DESIGN REVIEW BOARD – URBAN DESIGN PANEL

AGENDA - AMENDED 6/29/2021

A. CA 21-281

**Planning Staff Report to
Design Review Board - Urban
June 25, 2021**
for the July 1, 2021 Public Hearing

SITE PLAN

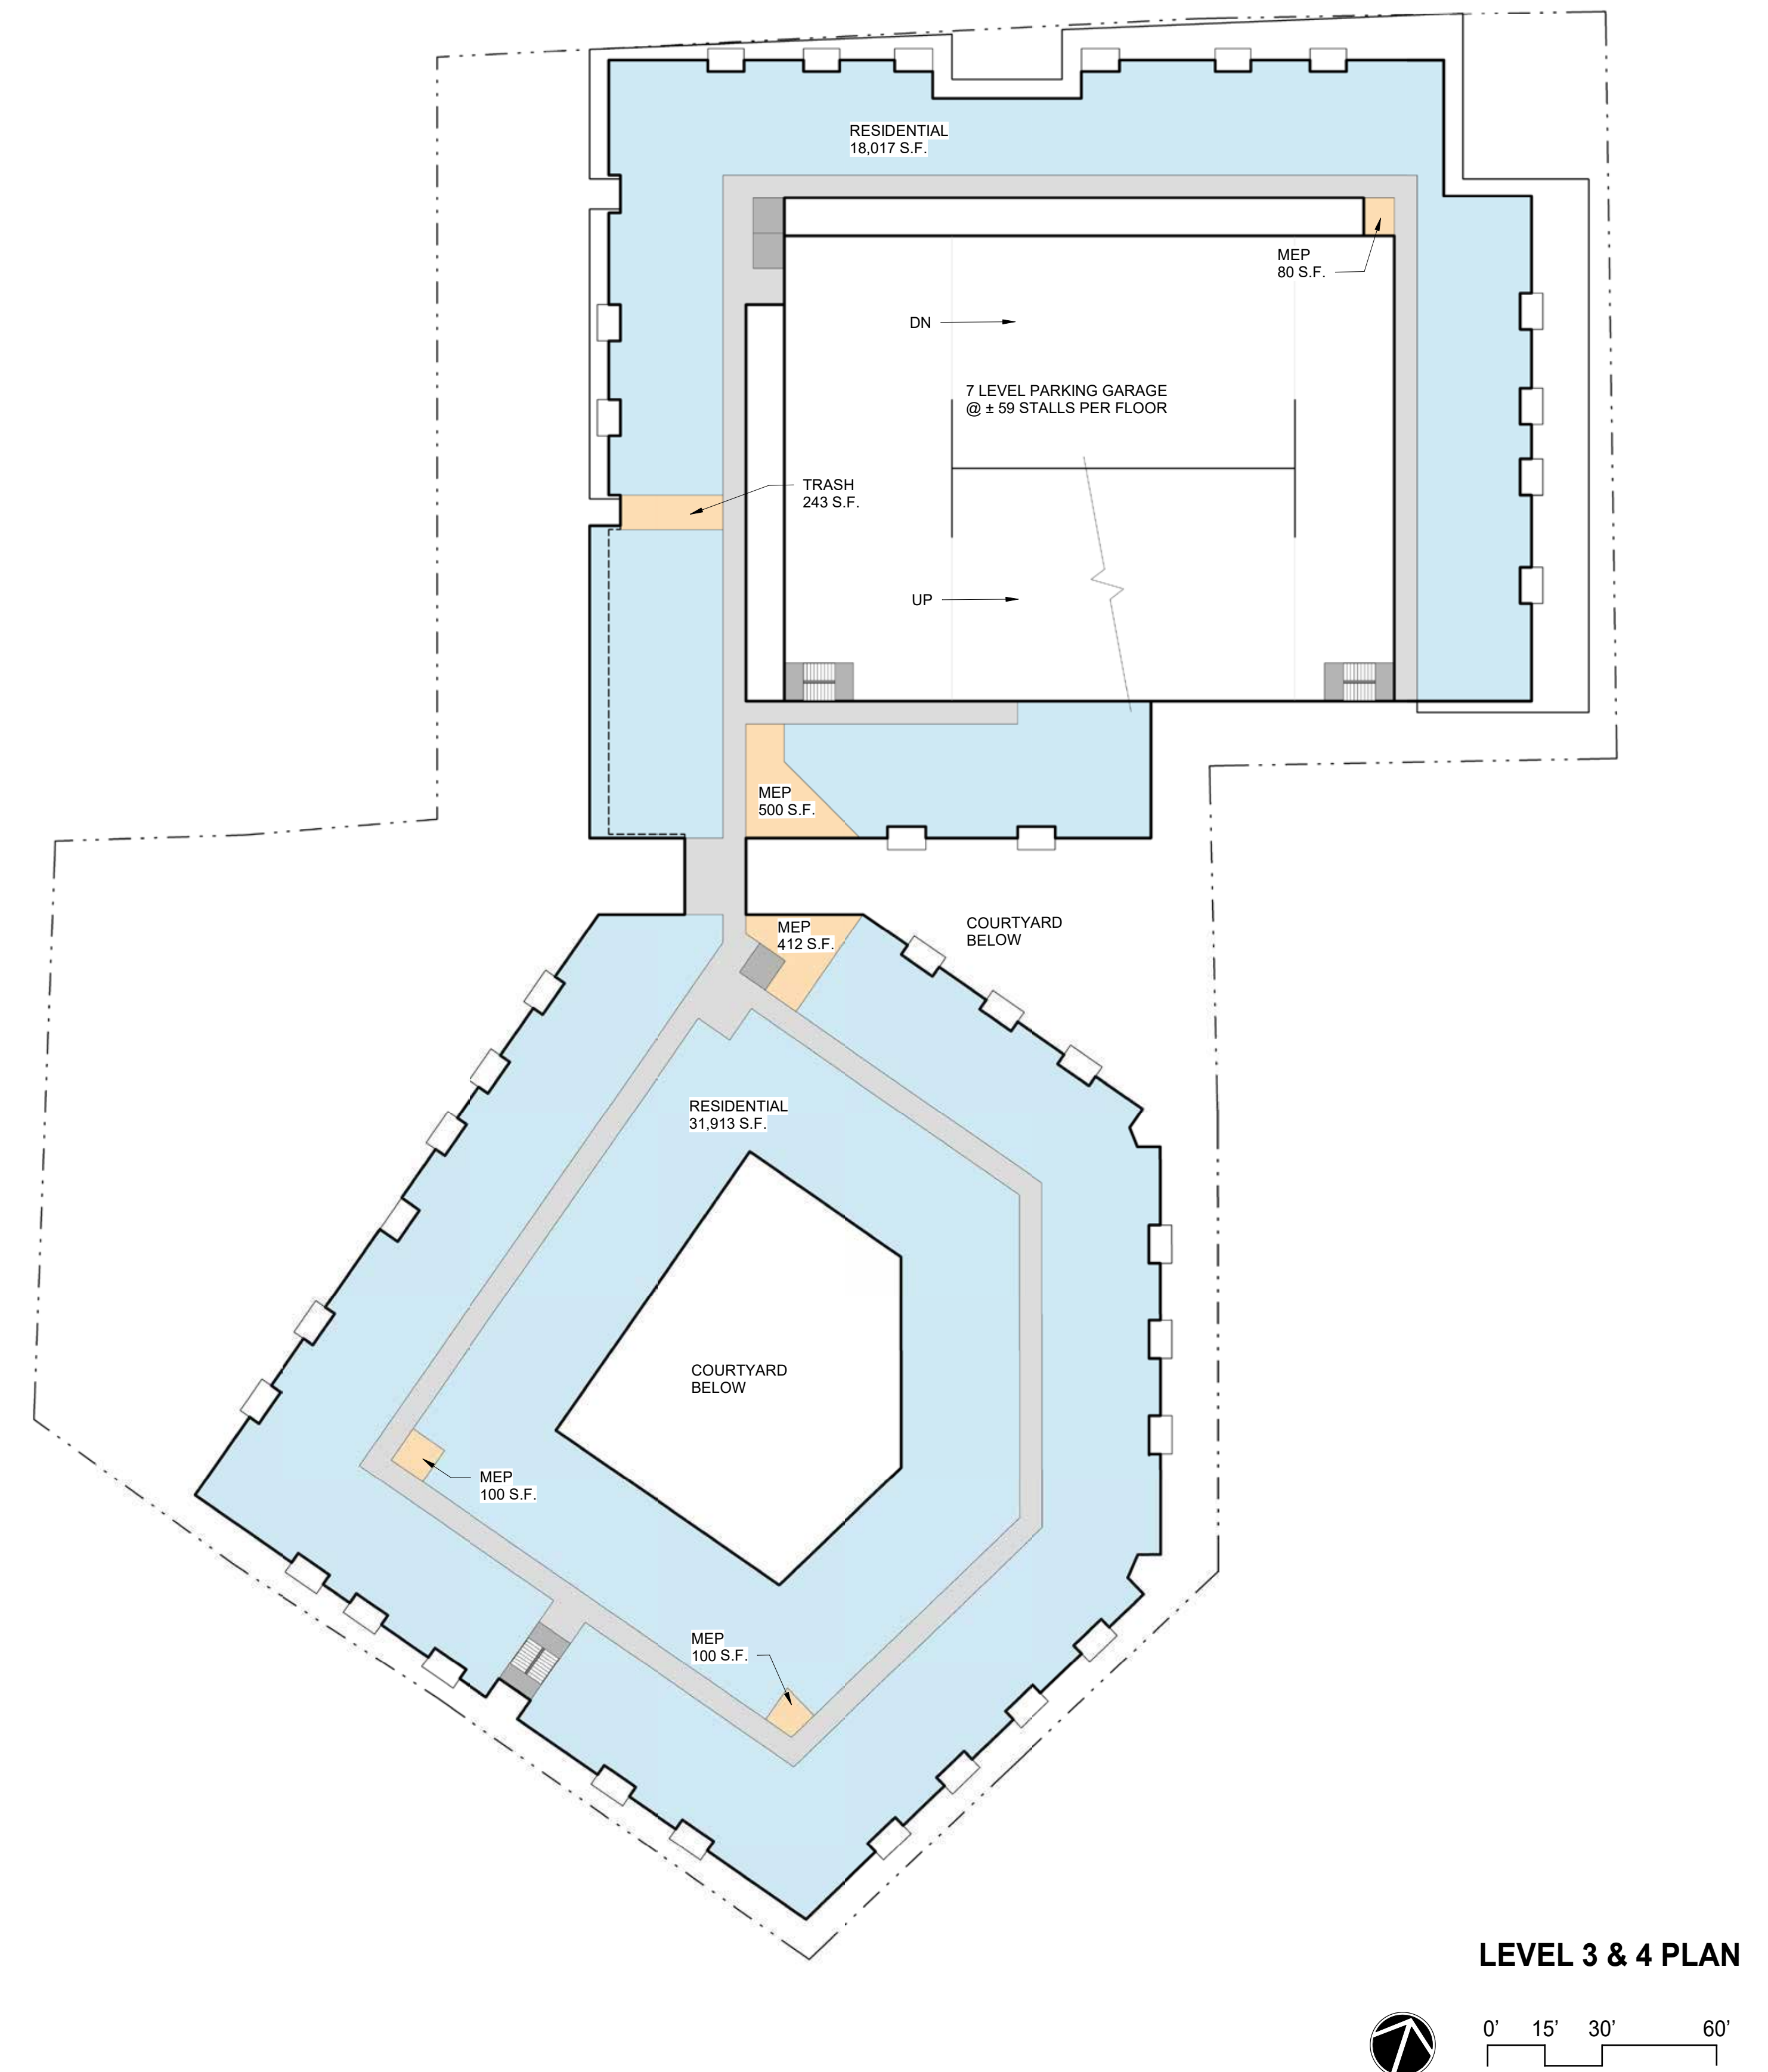
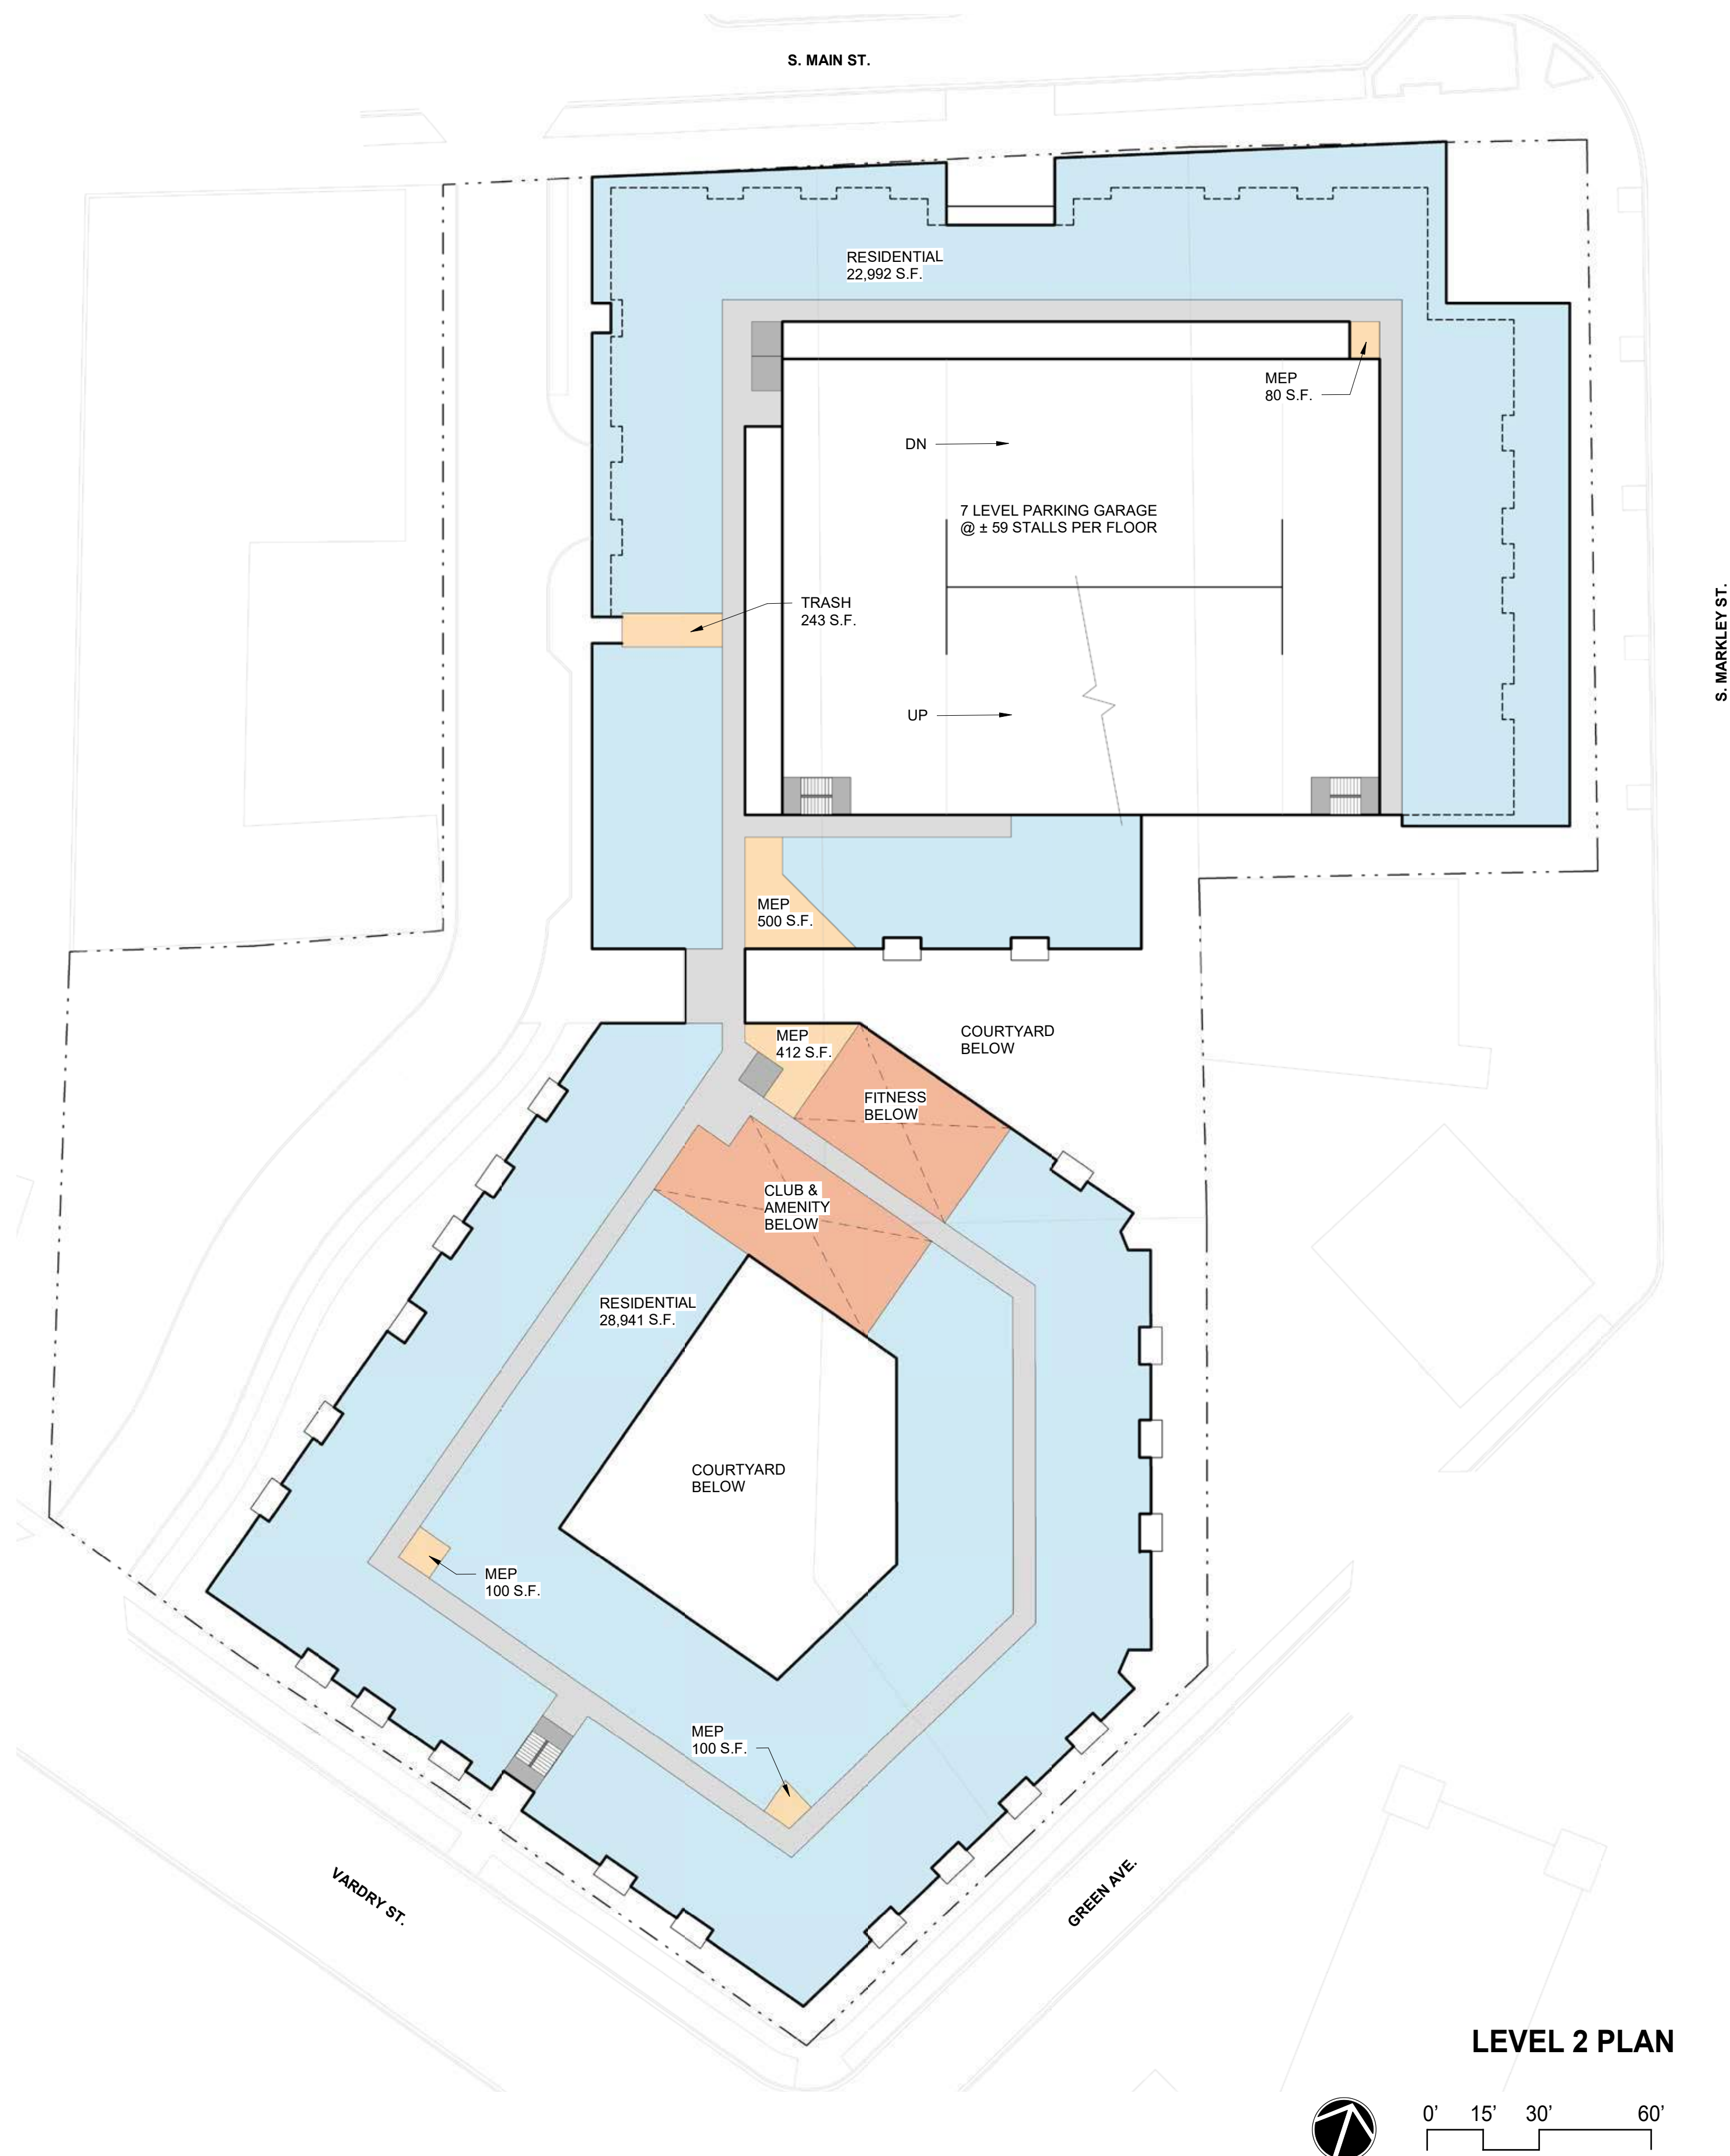
This building is a total of five (5) stories. The street facing massing is four (4) stories with a stepped back one-story top floor. The depth of this stepped back story is not shown in the plans. In accordance with PRI 2.4, staff finds the step back should be the minimum of 20 feet to not appear significantly taller than the adjoining M West Townhomes or the Historic Allen Temple AME church on the other side of Green Avenue.

Staff finds more detail of the northern portion of the alley will be required for the architecture plan review to ensure the design is consistent with the guidelines, promotes a safe pedestrian environment and promotes interaction through the area and to surrounding buildings.

Staff notes a reconfiguration of the northern extent of Building B and the private courtyard between the two buildings, as a mirrored image of the base proposal, would position the private plaza next to the alleyway and would enhance the atmosphere and use of both the courtyard and alley. Staff finds this would allow activity next to the alley and would open the courtyard to the afternoon sun. As of now, the courtyard would be cut off from both the morning sun, due to the adjacent two-story building, and from the afternoon sun due to the apartment complex. The modification would create a space that could be used for longer periods of the day and year.

- 1. Site plan approval is contingent upon building architecture approval. The DRB maintains the right to require minor site plan modifications that may result from review of the final building design.**
- 2. Applicant is to work with staff and conduct an informal review by a 2-Member DRB Committee for the design specifics of the alleyway.**
- 3. A landscape plan, completed by a licensed landscape architect, must be submitted for architectural review approval.**
- 4. The 5th story of Building B should maintain a 20-foot step back from the façade wall of the first four (4) floors to maintain appropriate massing to adjacent structures.**

5. A second loading and delivery zone should be provided on the southern end of the alleyway in order to provide enough space for moving and delivery trucks and to prevent any blockage of the alley's travel lanes.

LANDSCAPE PLAN

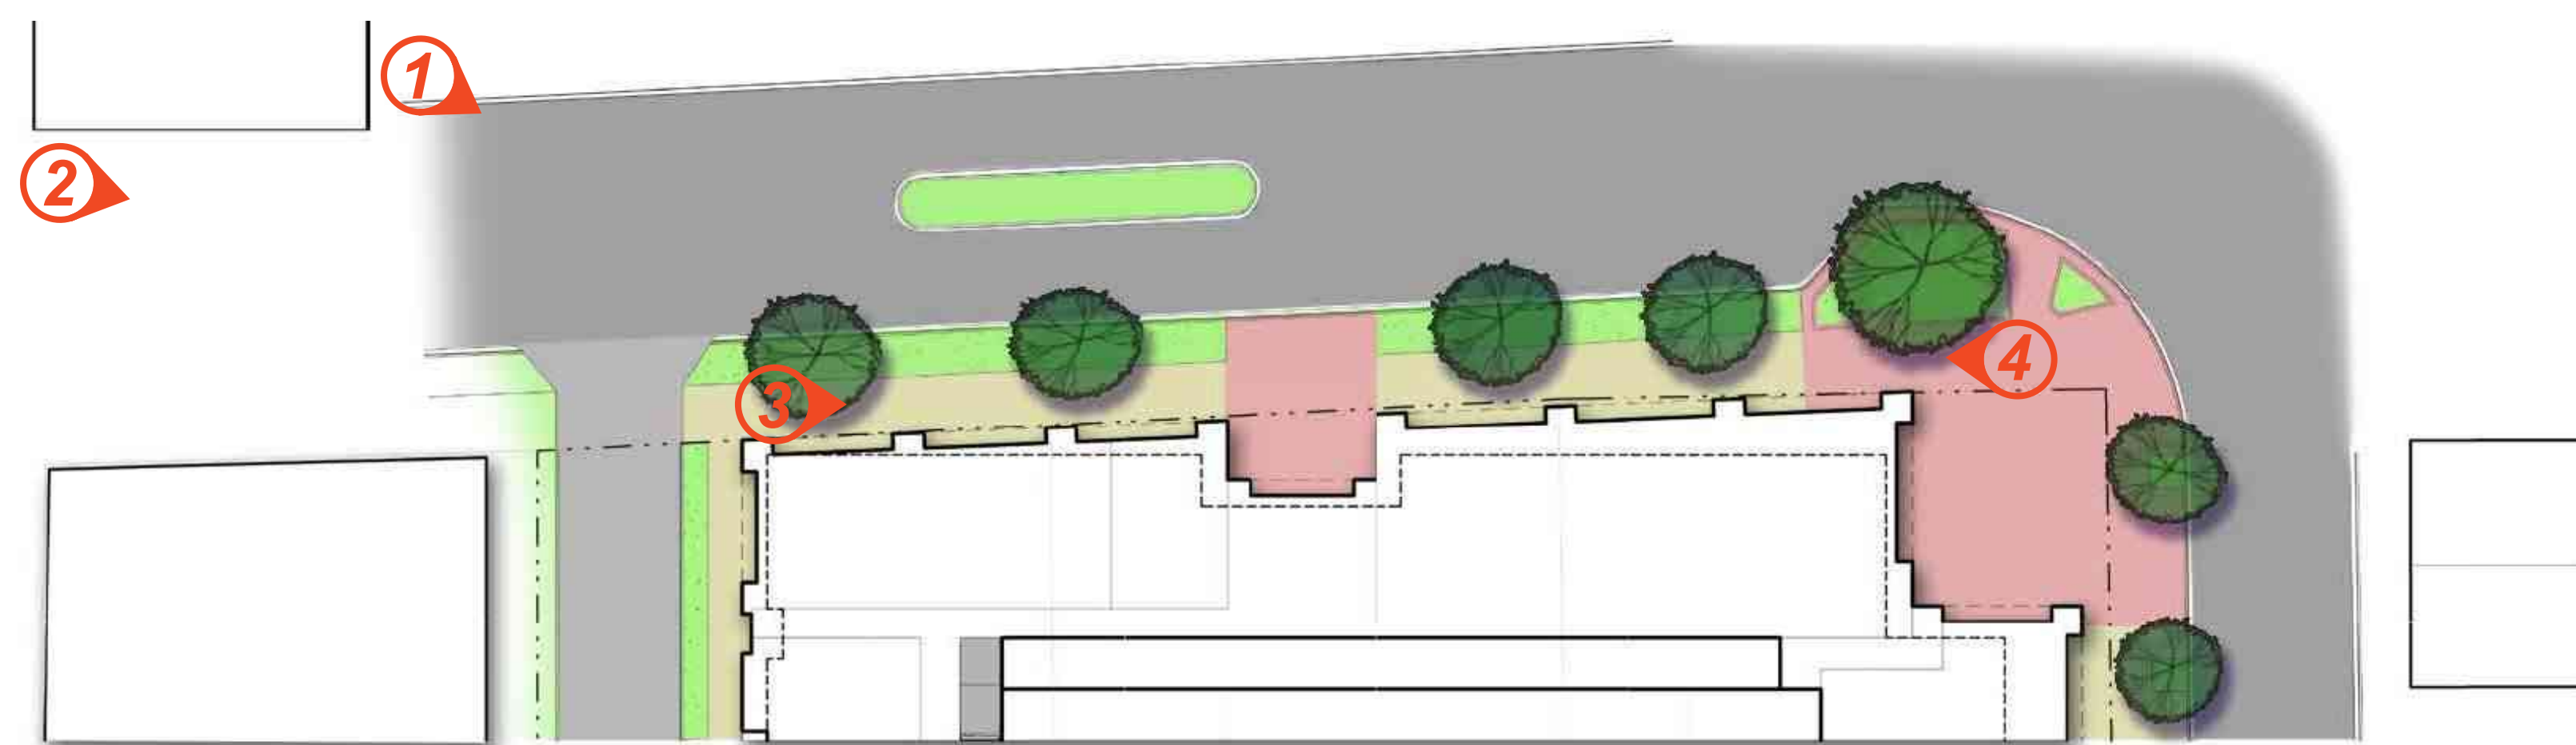
- **PUB 5.1:** The proposed landscape plan does not appear complete or well-conceived, even as a schematic level design. Primary access points show landscape and bushes in front of doors that are not provided access to any exit surface such as a sidewalk (Landscape Plan, Sheet L-001).

- Per the Landscape Plan, Sheets L-001-B & L-004, the applicant proposes trees in the pedestrian 'plaza' area directly under where the 2nd floor extends outward toward S. Markley St. Such placement, in reality, would result in the death of the trees. Bushes and shrubs are also shown blocking any entrance to the unspecified 'amenity' provided to activate the street at the corner of Green Avenue and Vardry Street.

- PUB 8.6: The plaza is shown on Page L001 "Landscape Plan" appears largely devoid of vegetation. The monolithic evergreen landscape plan does not provide shade or enrich "human interest, including seasonal variety, multi-sensory appeal, or distinctive physical characteristics."
